STAFF REPORT

DATE: January 5, 2021 updated January 7 and 11, 2021

RE: **1316 Royal Street-1319 William Street**
(TP2020-00008 Conceptual Landscape Code Review)

FROM: Karen DeMaria, City of Key West Urban Forestry Manager

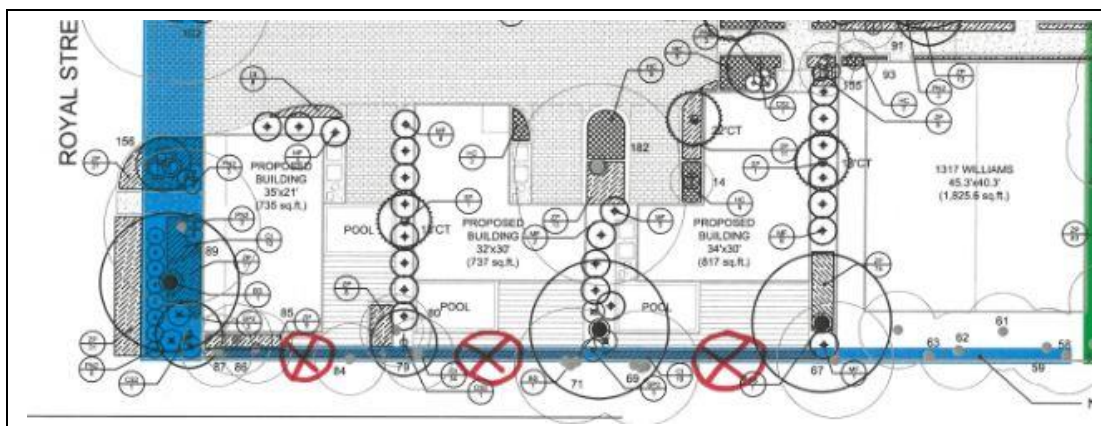
The City has determined that a more restrictive buffer requirement is needed along the western side of the property due to the plans showing the backyard that includes decks and pools of at least two homes abutting the neighboring property (see below).

- A. Southeast Side Buffer Yard: this area is adjacent to multifamily properties therefore this is a "B" bufferyard which requires 40 plant units per 100 linear feet. This bufferyard landscape area is proposed to be 5 feet wide therefore a total of 71 plant units for the 178 linear feet of property line area is required (does not include the 22 feet of property required for street buffer for William and Royal Street areas).

A total of 201 plant units (existing and new plants) are proposed for this area therefore, the plant unit count complies with this section of code.

- 20 points Existing canopy trees* (1-Gumbo Limbo #141 and 1-Royal Poinciana #139)
- 95 points Ornamental/Subcanopy trees and palms (1-new Geiger, 1-existing Jamaican Caper #11, 1-transplanted Thatch palm #181, and 16-new Simpson Stoppers)
- 86 points Shrubs (48-Cocoplum and 38-Coontie)

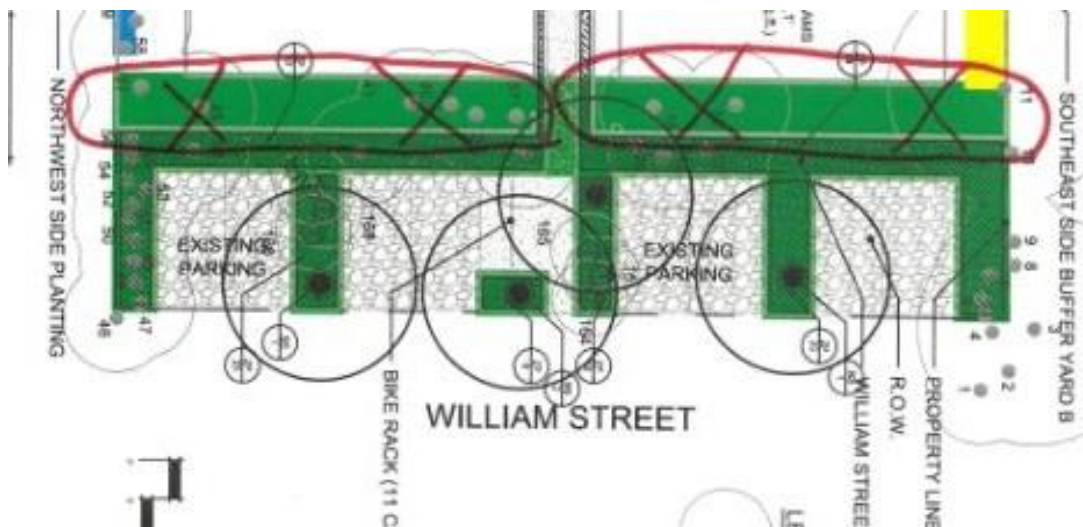
- A. Royal Street: The submitted landscape plan proposes to create a 10 ft wide landscape area with a total of 154 plant units* (existing and new plants) proposed for this area:

30 points	Existing canopy trees (3-Royal Poincianas #89, #102, & #108)
15 points	Ornamental/Subcanopy trees and palms (3-existing palms being transplanted into this area #156, #113, & #116, 1-new Geiger, and 1-new Simpsons Stopper tree)
109 points	Shrubs (32-Wild Coffee, 63-Cocoplum, 3-Spartina plants, and 11-Coontie plants)

The proposed plan meets the requirements for plant units. A waiver has been requested to reduce the width of the required landscape area from 20 ft to 10 ft.
